**FINAL
RESPONSES TO COMMENTS ON DEIR**

1601 Mariposa Street Mixed Use Project

PLANNING DEPARTMENT
CASE NO. 2012.1398E

October 15, 2015

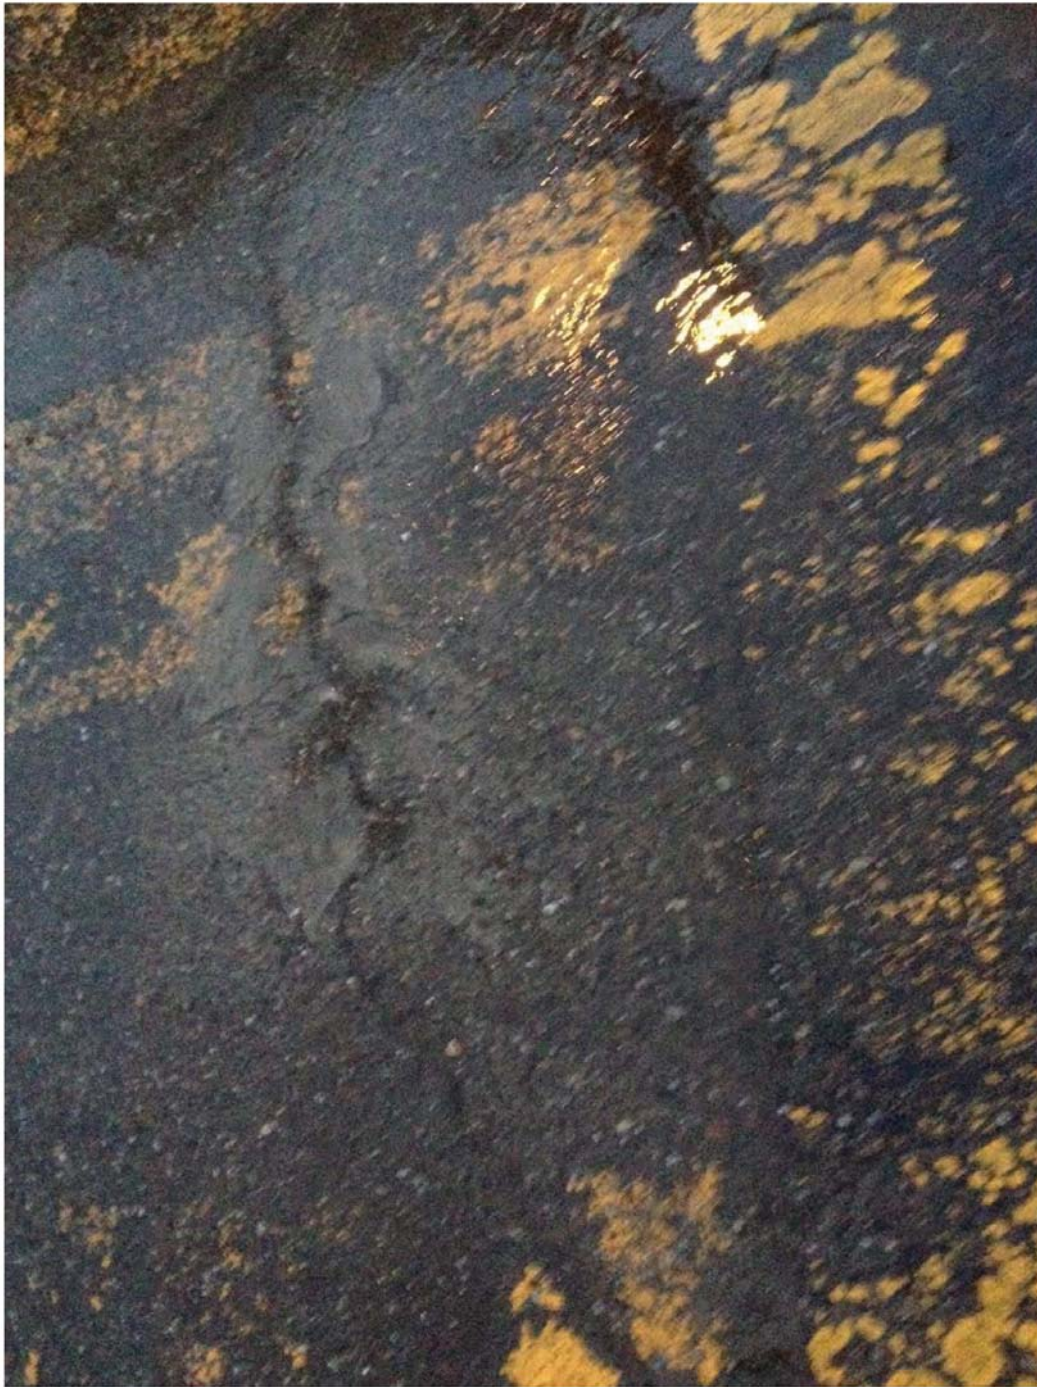
P. 53 Construction: Mention is made of rammed aggregate piers for the West Building and Part of the East Building. How will the water line on Carolina which recently ruptured and the nearby gas lines be safeguarded? What gas lines go to the Anchor Steam facility?

Crack in pavement across Carolina St cross walk at 18th – with water bubbling from broken main January 2015.

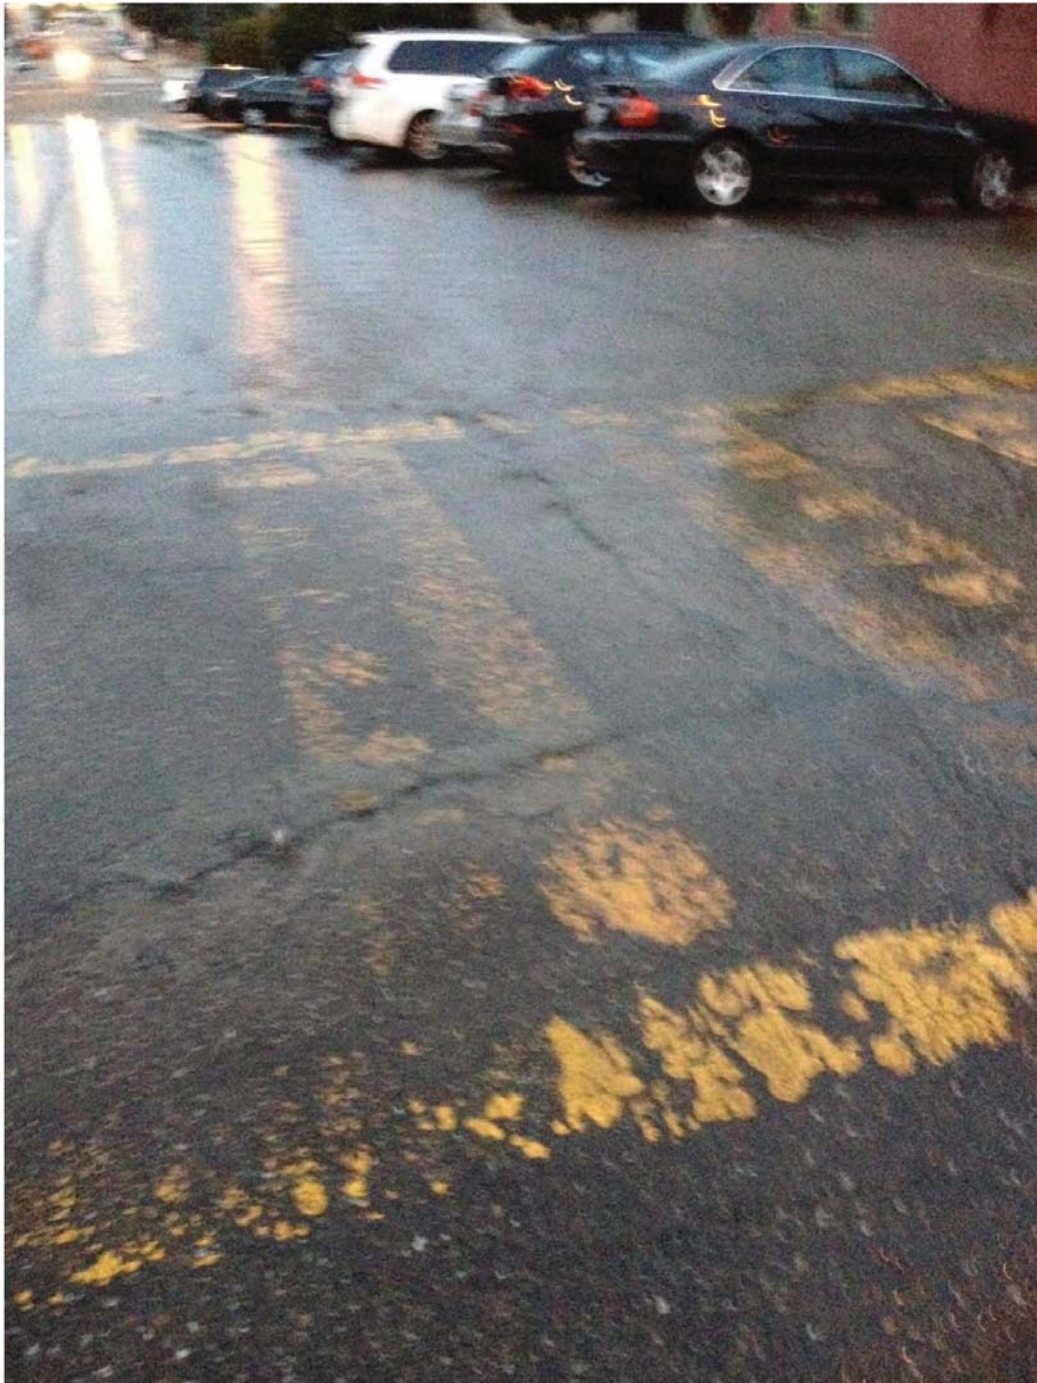
18th Street water main break flooding Carolina St between 18th and Mariposa
January 18, 2015. Notice poorly maintain school cross walk to SFUSD property.

Looking across Carolina at 18th earlier in the water main break January 2015. Any soil disturbance or ground shaking activities may disturb aged infrastructure such as this water main.

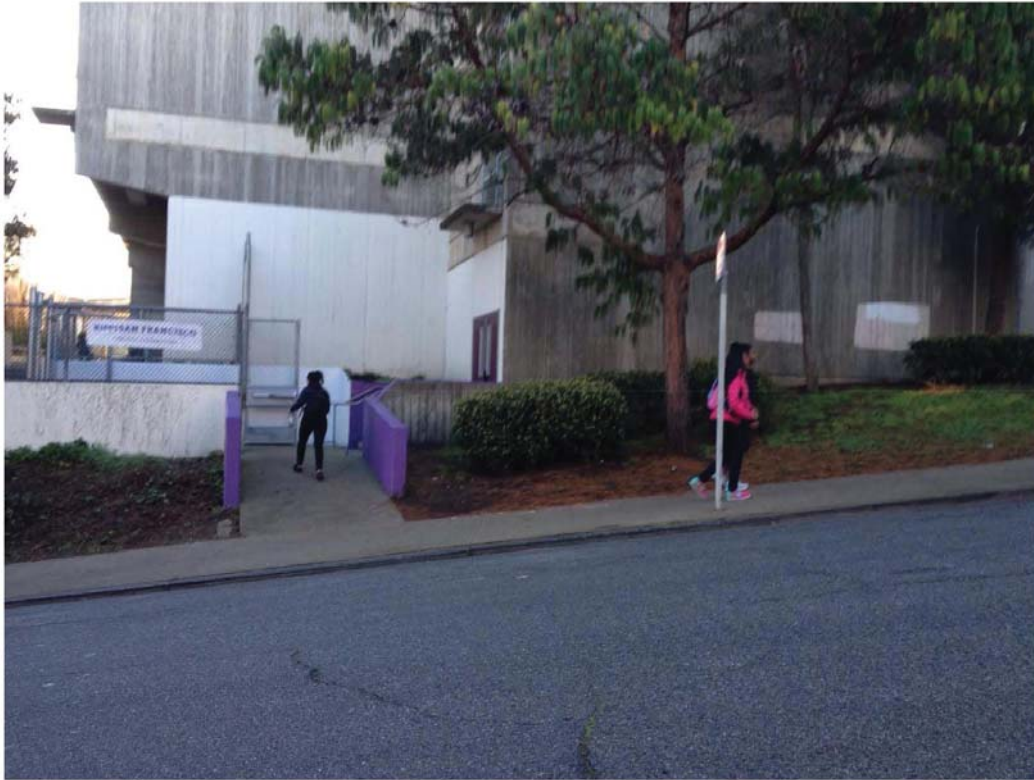
Here are two pictures of the entrance to KIPP on 18th Street across from the proposed project. The pedestrian, bicycle and traffic safety impacts on this charter school appear to have been completely overlooked by the DEIR and project proponents:
